UNITED STATES  
NUCLEAR REGULATORY COMMISSION  
WASHINGTON, D.C. 20555-0001

SUBJECT: SEABROOK STATION, UNIT NO. 1 – STAFF ASSESSMENT OF RESPONSE  
TO 10 CFR 50.54(f) INFORMATION REQUEST – FLOOD-CAUSING  
MECHANISM REEVALUATION (CAC NO. MF6782; EPID NO.  
000495/05000443/L-2015-JLD-0019)

STAFF ASSESSMENT BY THE OFFICE OF NUCLEAR REACTOR REGULATION

SEABROOKSTATION, UNIT NO. 1

Figure 3.2-3. Maximum LIP flow depth (west portion of site). Indices of POIs included.  
(Source: FHRR Figure 4-14).

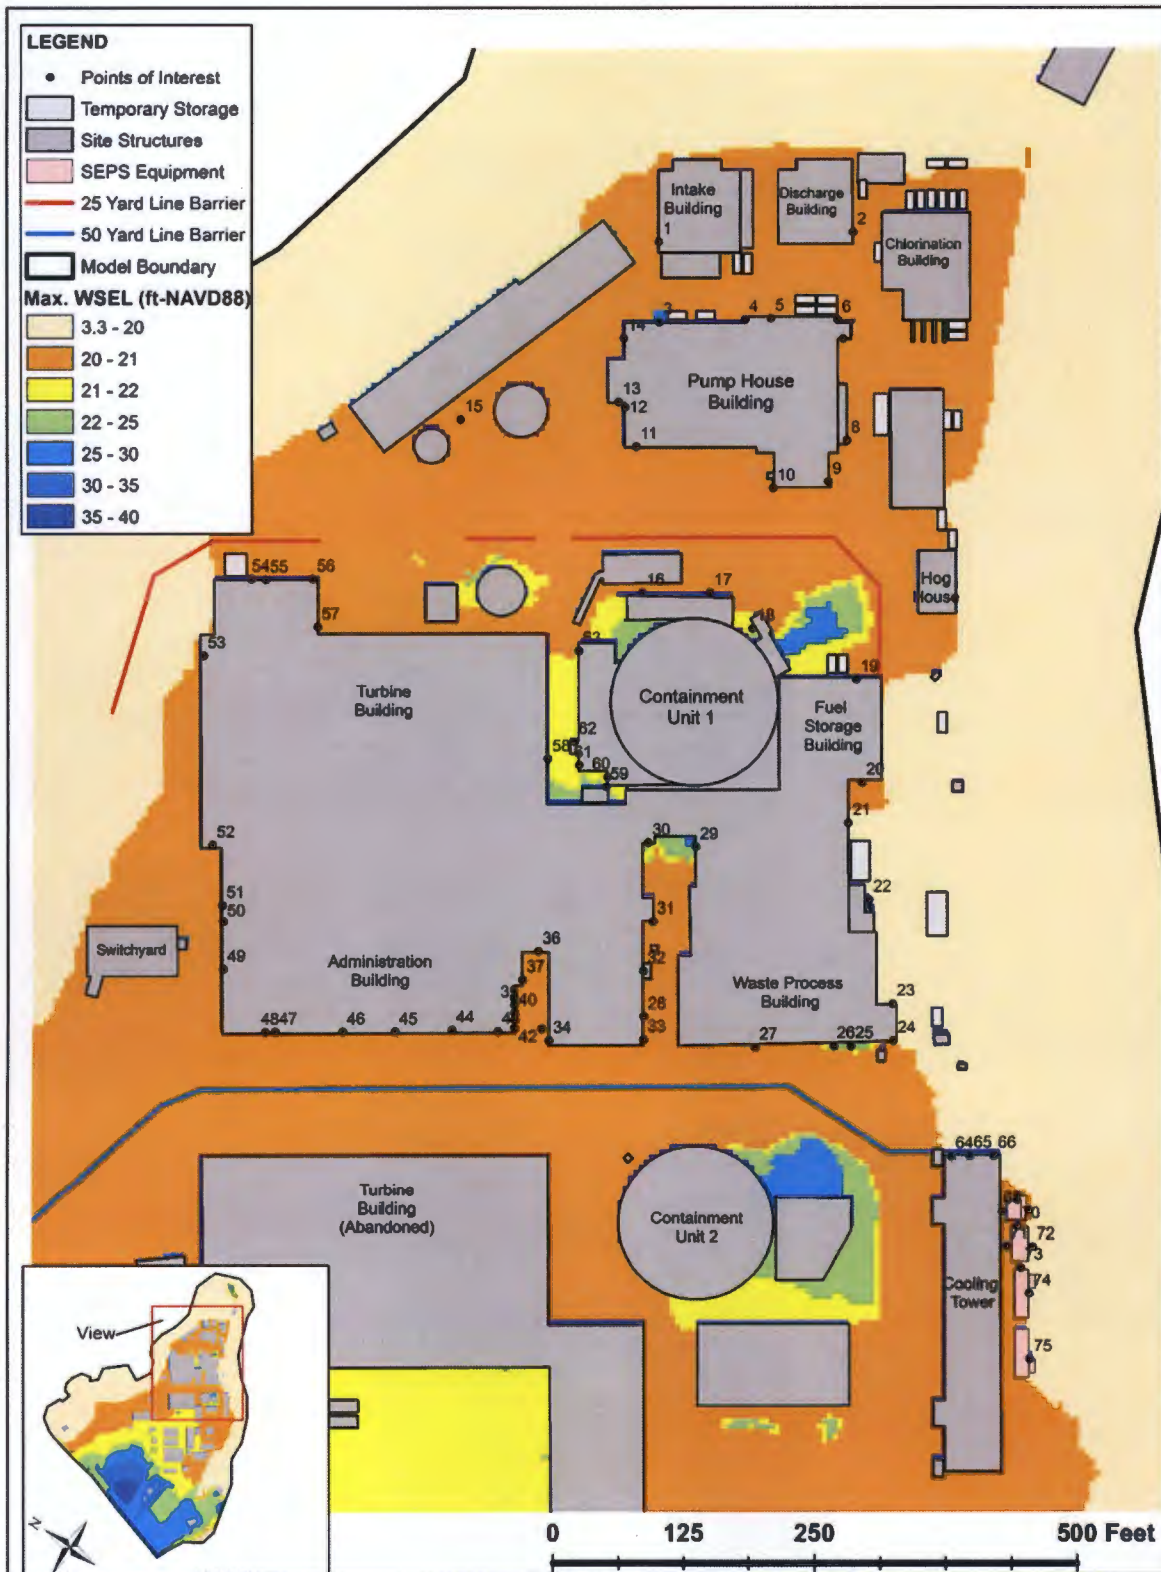
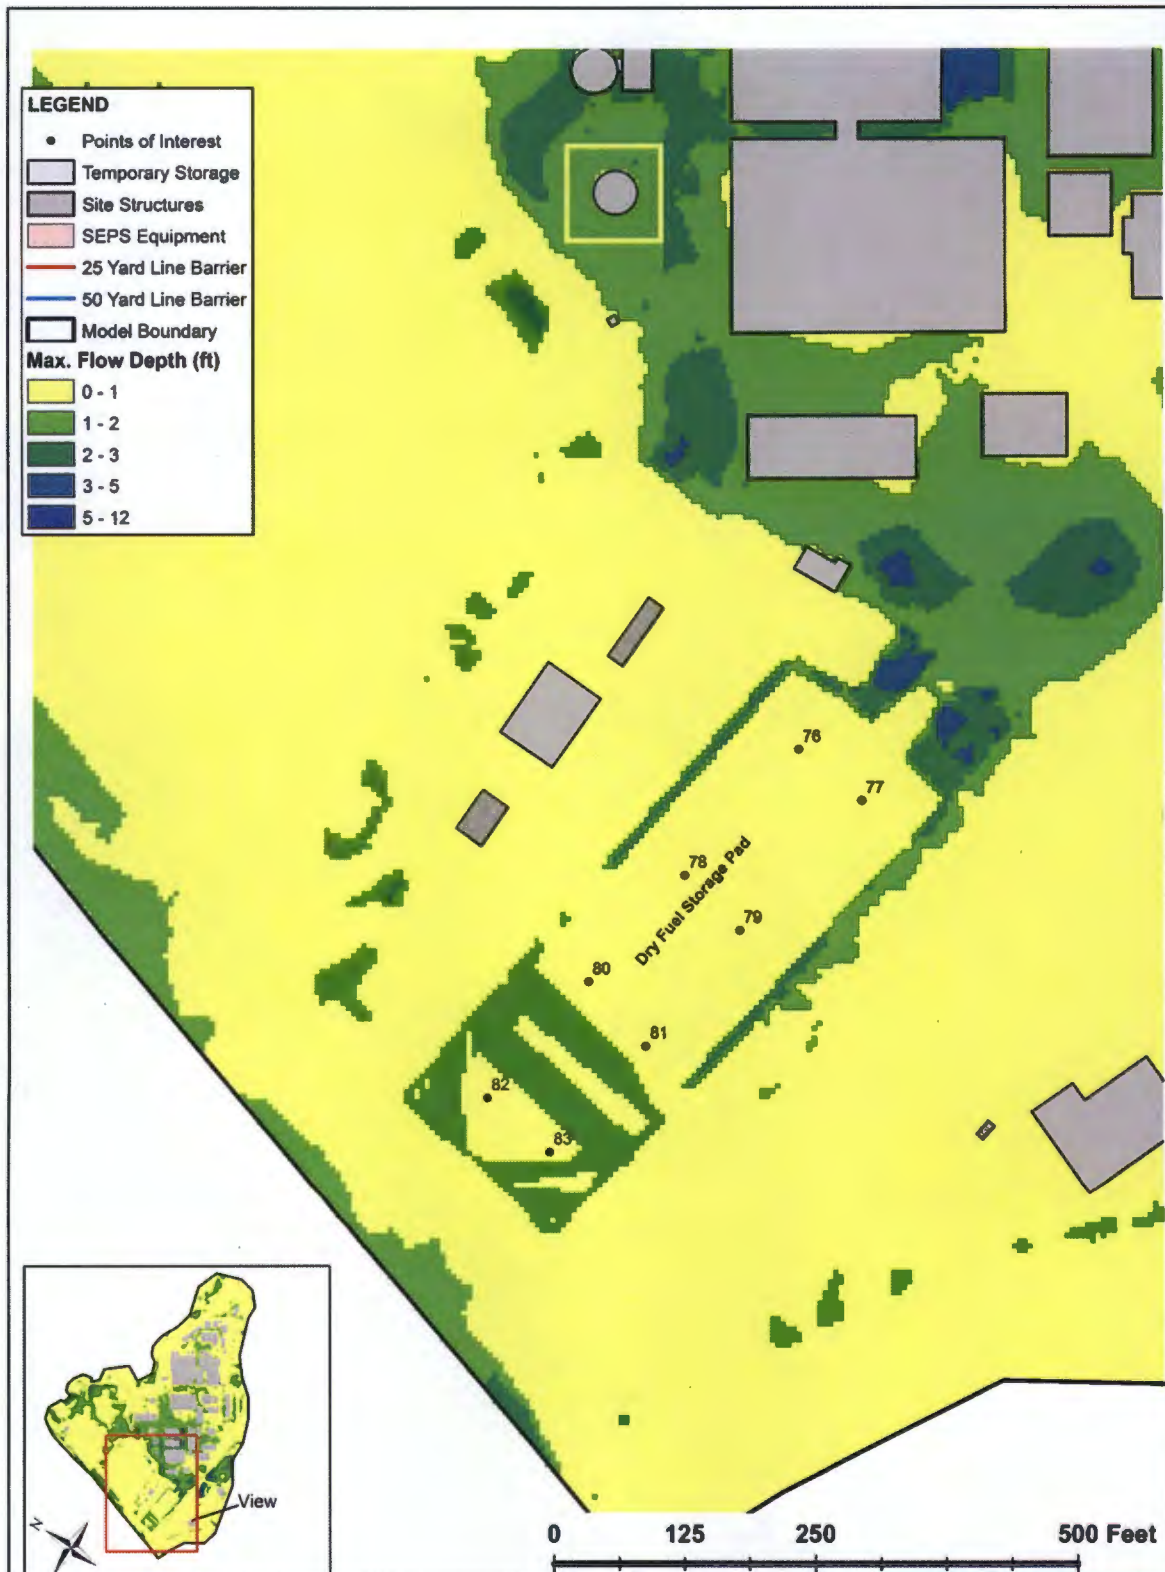
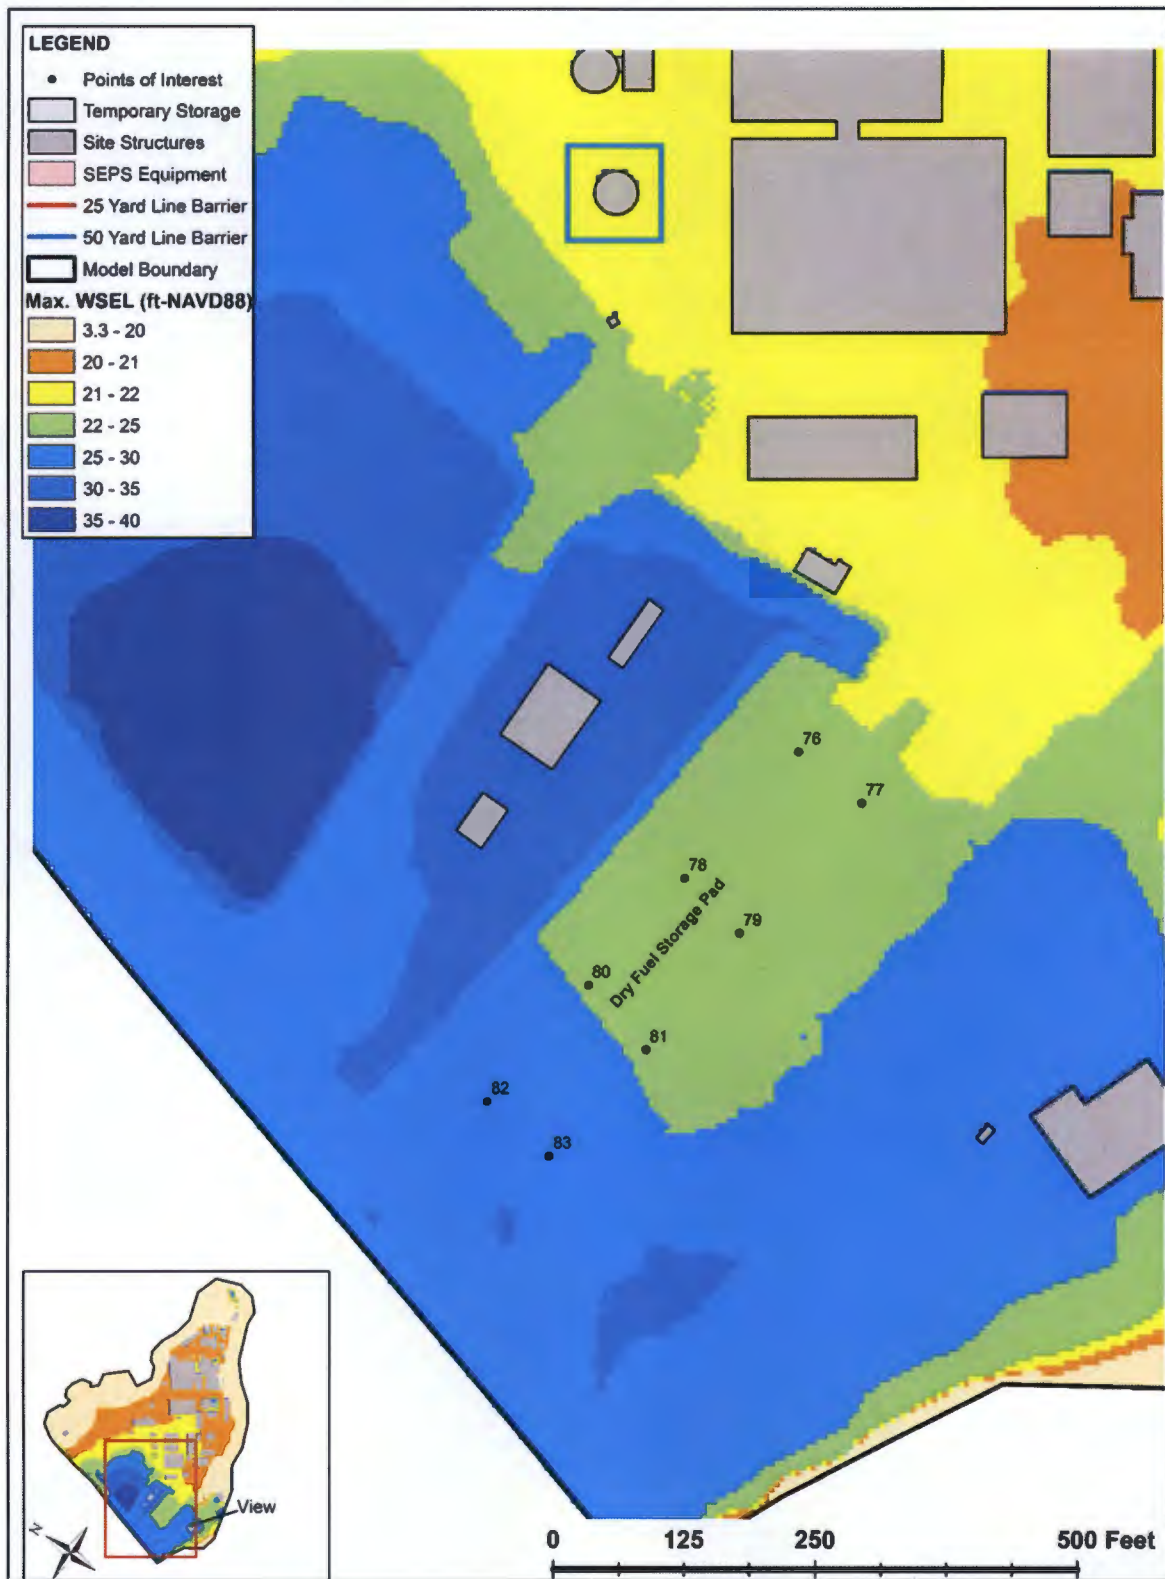
The NRC staff reviewed the licensee's model setup including the hydraulic parameters, surface topography, hydraulic boundary conditions, and the grid resolution in the FLO-2D model. The NRC staff checked the modeling's mass conservation error, and found the value to be reasonable. The licensee's LIP maximum flood depths and peak water surface elevations are shown for the east portion of the site in Figure 3.2-1 and Figure 3.2-2, respectively in this assessment. The licensee's LIP maximum flood depths and peak water surface elevations are shown for the west portion of the site in Figure 3.2-3 and Figure 3.2-4, respectively in this assessment. These figures also show the locations of the 83 points of interest.
